Addendum No. 1

RE: Contract # C205036

Robeson County (U-5797)

SR-1997 (FAYETTEVILLE RD) FROM FARRINGDOM ST TO EAST 22ND ST

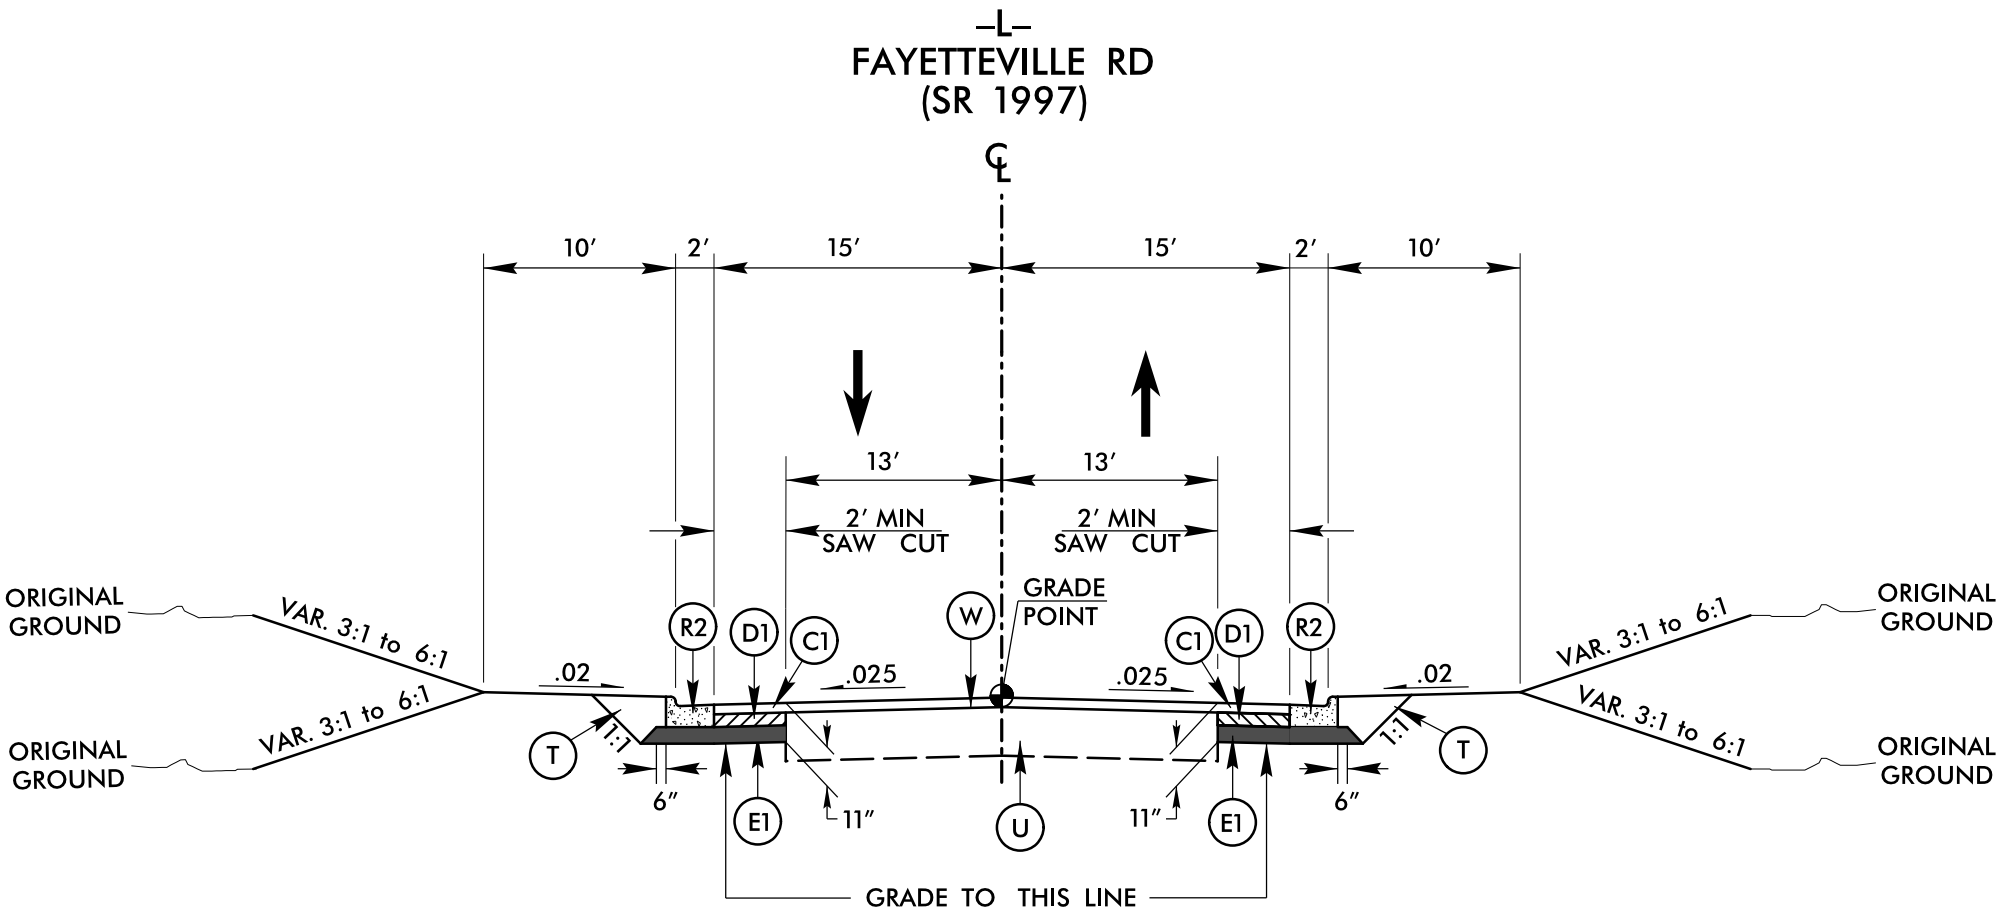
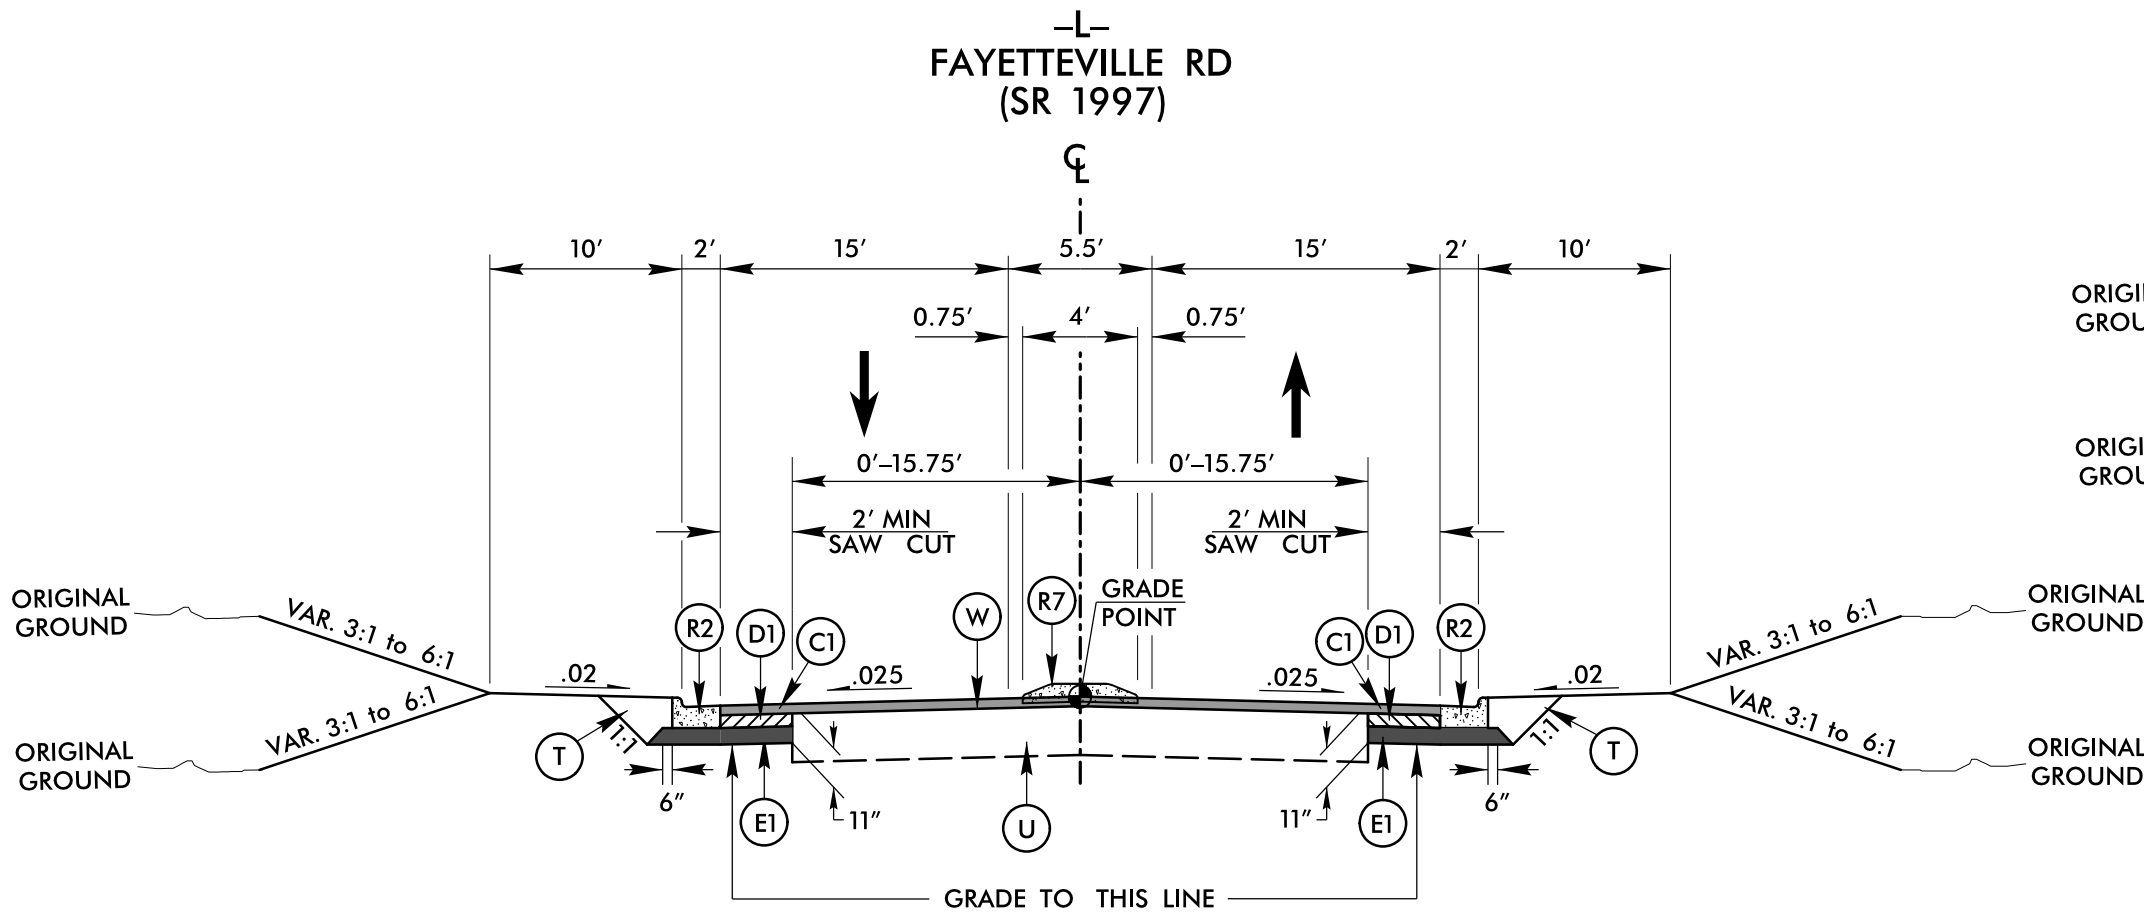
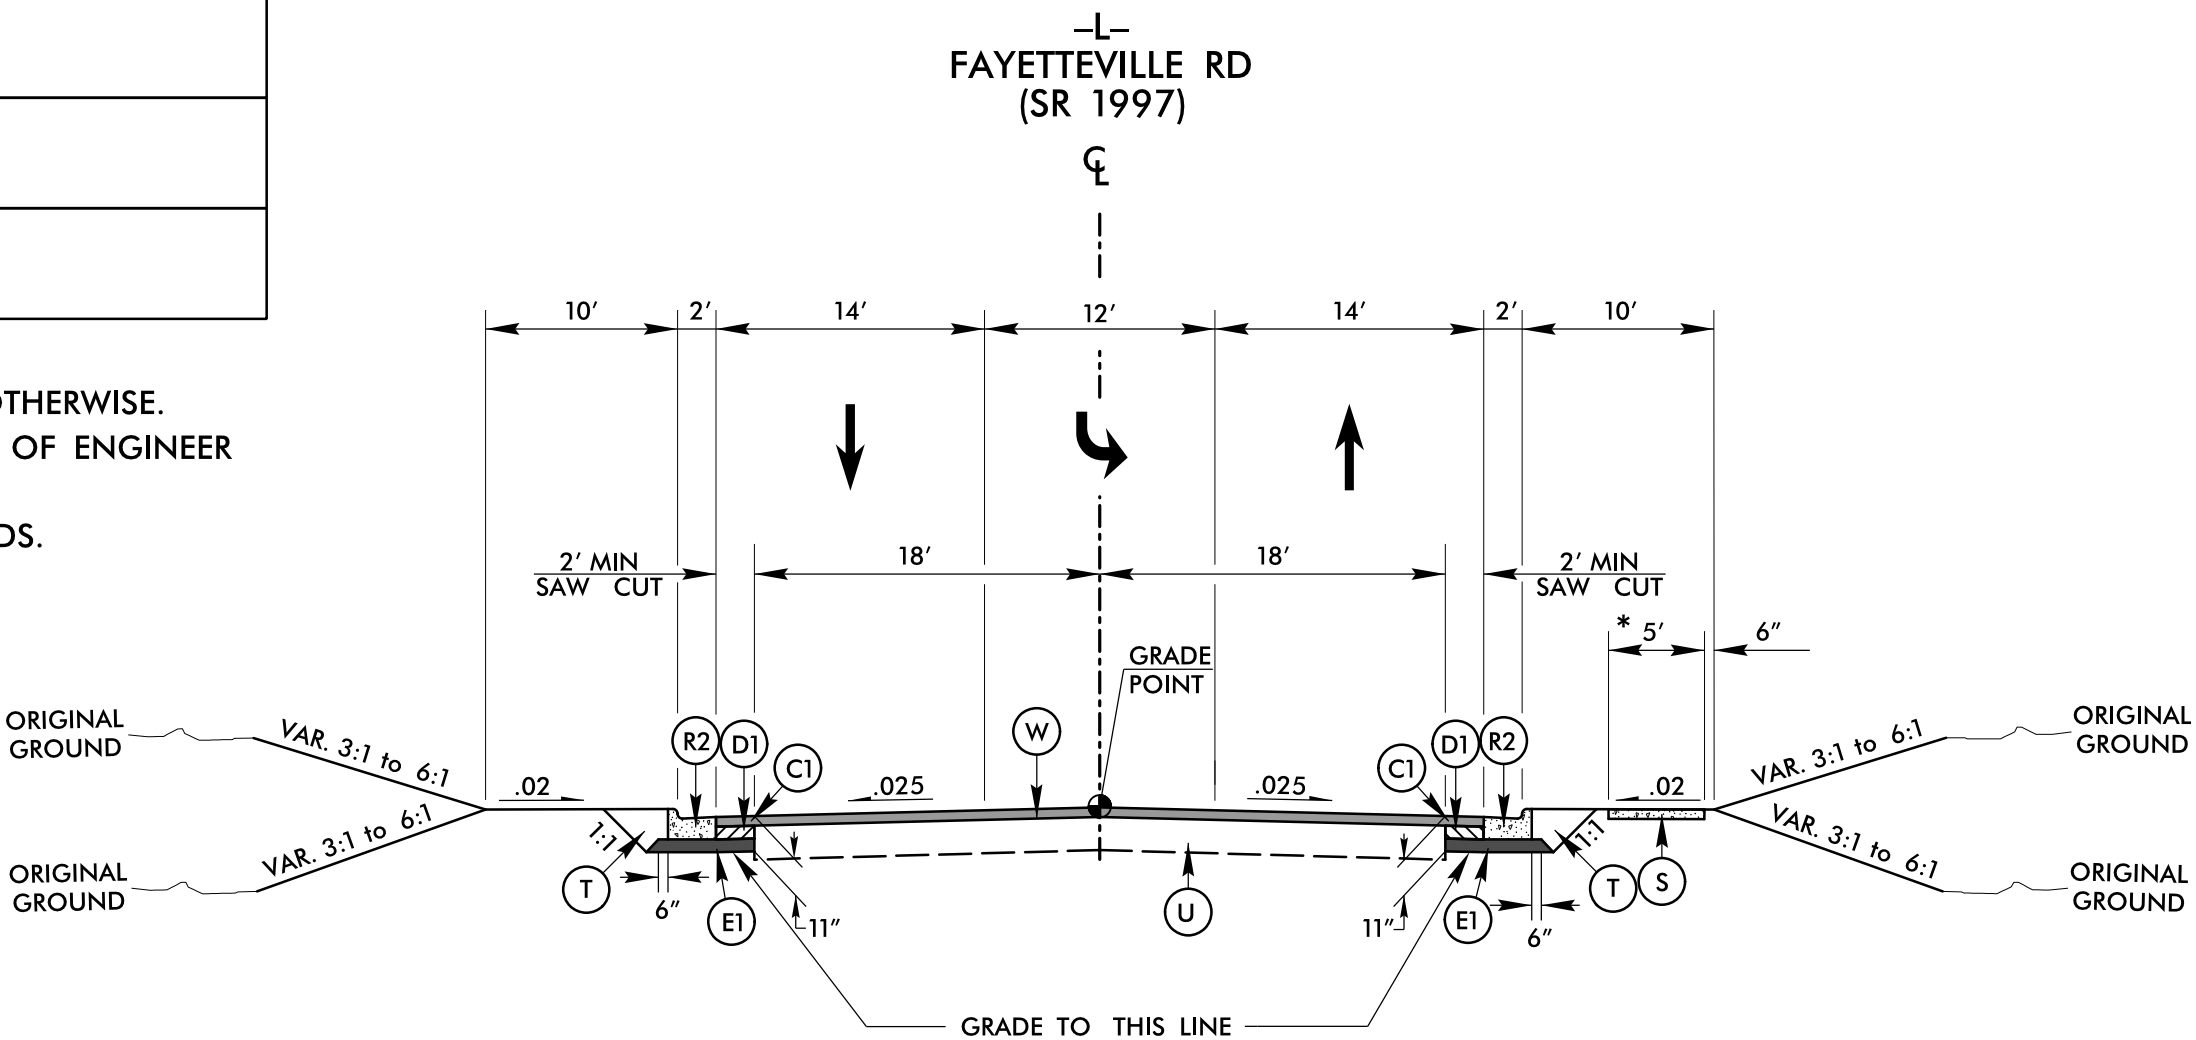
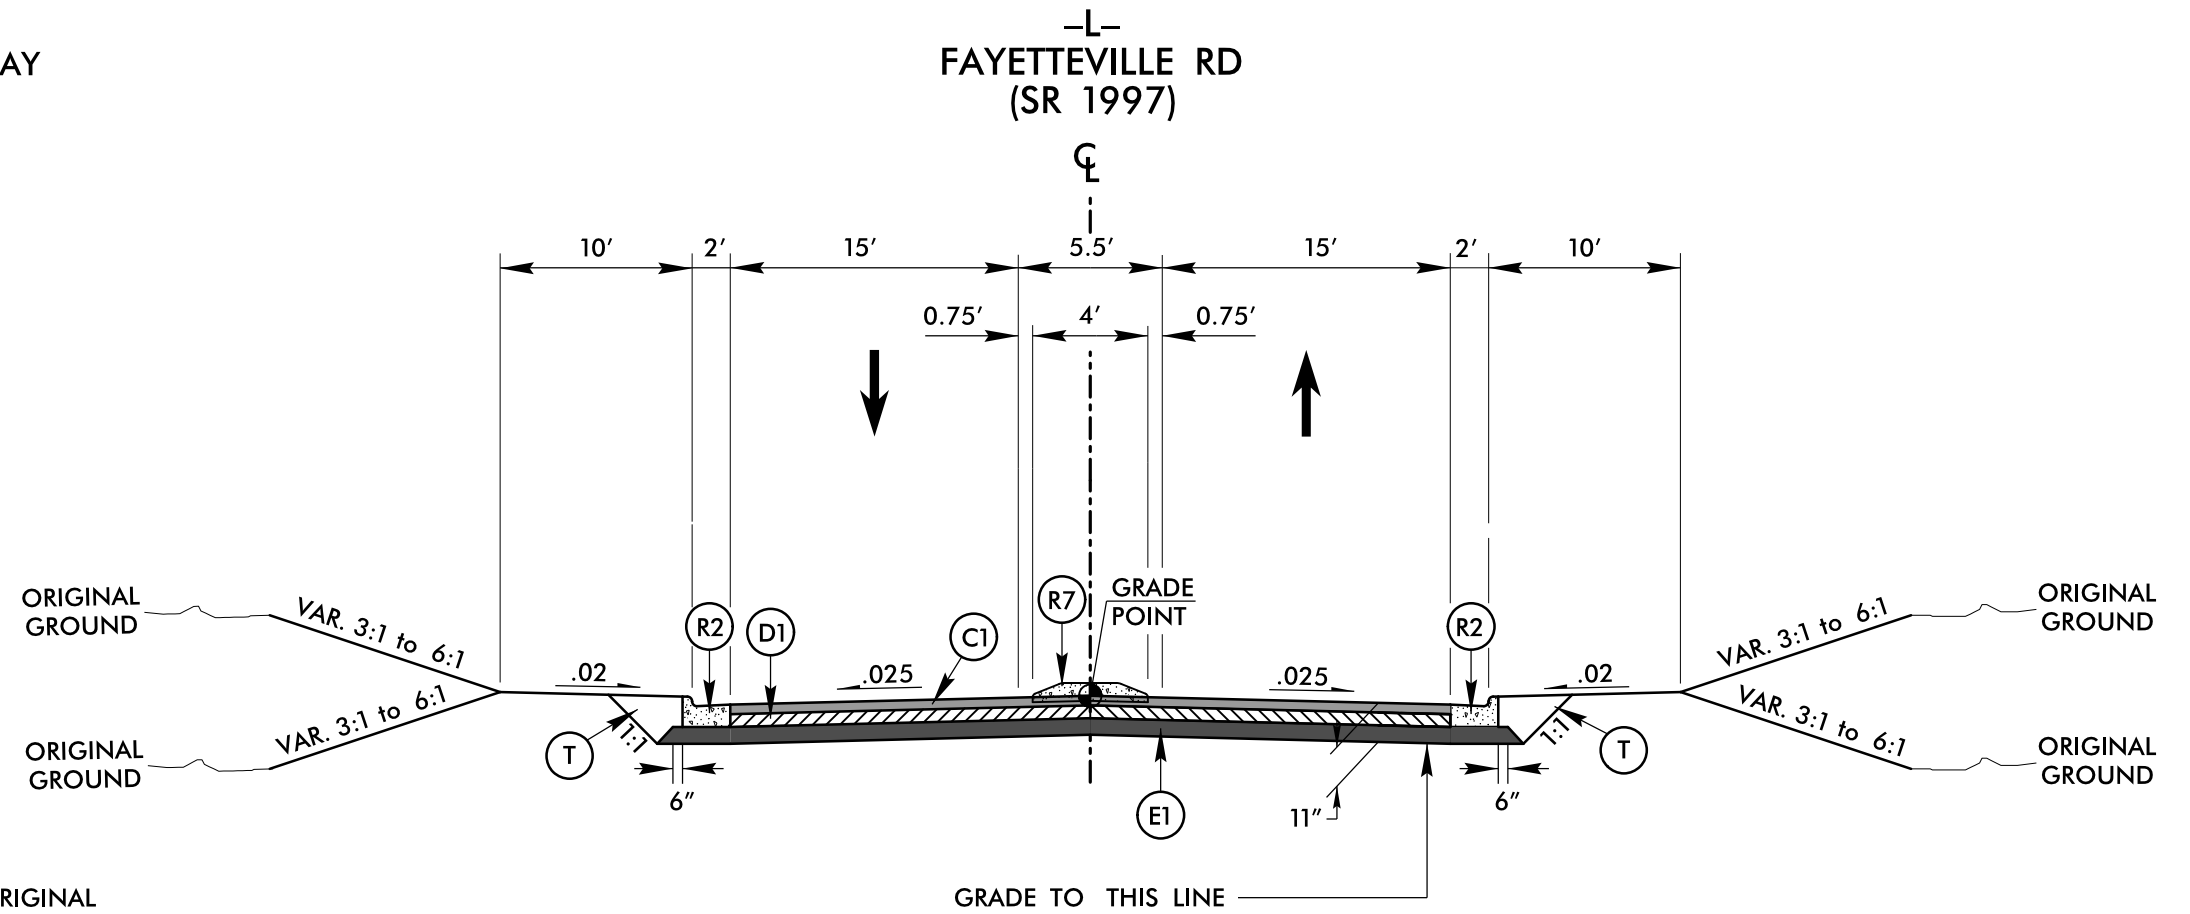
Sheet No.	Revision
Title Sheet	Revised Letting Date and -Y2- End Construction Label
1A	added sheet 2A-5 to index
2A-1	Typical Section 1 renamed to 1A. Typical Section 1B created to show full depth
2A-2	Typical Section 5 renamed to 5A. Typical Section 1B created to show full depth
2A-3	Typical Section 8 updated to show saw cut varies from 2' to 10' Typical 10 renamed to 10A. Typical Section 10B created to show full depth Detail G updated to match plan view Detail H deleted Typical Section 12 moved to sheet 2A-4
2A-4	Typical Section 12 renamed to 12A. Typical Section 12B created to show full depth
(New) 2A-5	The previous sheet 2A-4 moved to sheet 2A-5 -L- and -Y2- stations added to Typical section 13 and removed from typical section 14 Typical Section 14 updated with -Y- stations and added concrete island
